Access Compliance Report

Public Rights-of-Way

Intersection ID: 30484	Main Street: GLORY_MEADOW_CT	Cross Street: PLANTERS_ROW_DR	Location: NE
ADA ID: 09F46B8F8E37	Ramp Type: PerpDiag	Initial Pass/Fail: Fail	Overall Compliance: No
Severity Score: 8.75			
Codes/Mitigation Info/Possible Solution		Field Measurements/Component Compliance

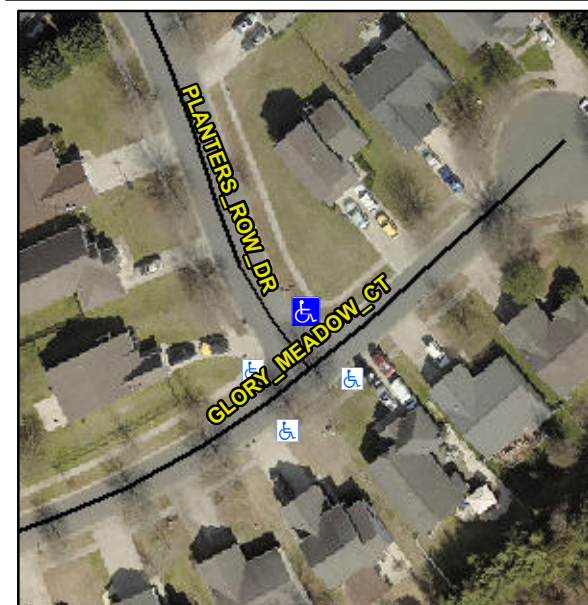
Not Found, R304.5.1

Compliance	Description	Data	Compliance	Description	Data
N/A	Ramp Length (in)	83.0	Yes	Ramp Slope (%)	6.5
No	Ramp Width (in)	36.5	Yes	Ramp XSlope (%)	0.3
N/A	Flare Type LT	N/A	N/A	Flare Type RT	N/A
N/A	Flare Slope LT (%)	N/A	N/A	Flare Slope RT (%)	N/A
N/A	Flare Traversable LT?	N/A	N/A	Flare Traversable RT?	N/A
N/A	Landing Length (in)	N/A	N/A	DWS Provided?	N/A
N/A	Landing Width (in)	N/A	N/A	DWS Contrast?	N/A
N/A	Landing Slope (%)	N/A	N/A	DWS Length (in)	N/A
N/A	Landing X Slope (%)	N/A	N/A	DWS Full Width?	N/A
N/A	Landing Curb? (Y/N)	N/A	N/A	DWS Offset (in)	N/A
N/A	Shared Landing?	N/A			
N/A	Gutter Ponding?	N/A	N/A	Gutter Slope (%)	N/A
N/A	Gutter Lip Ht (in)	N/A	N/A	Gutter X Slope (%)	N/A
N/A	Painted X Walk1?	No	N/A	Painted X Walk2?	No
	X Walk 1 Direction	To SW		X Walk 2 Direction	To SE
N/A	X Walk 1 Width (in)	N/A	N/A	X Walk 2 Width (in)	N/A
	X Walk 1 Slope (%)	1.1		X Walk 2 Slope (%)	1.6
	X Walk 1 X Slope (%)	0.1		X Walk 2 X Slope (%)	0.7

Remove & Replace Curb Ramp With Two New Directional Ramps or Equivalent.
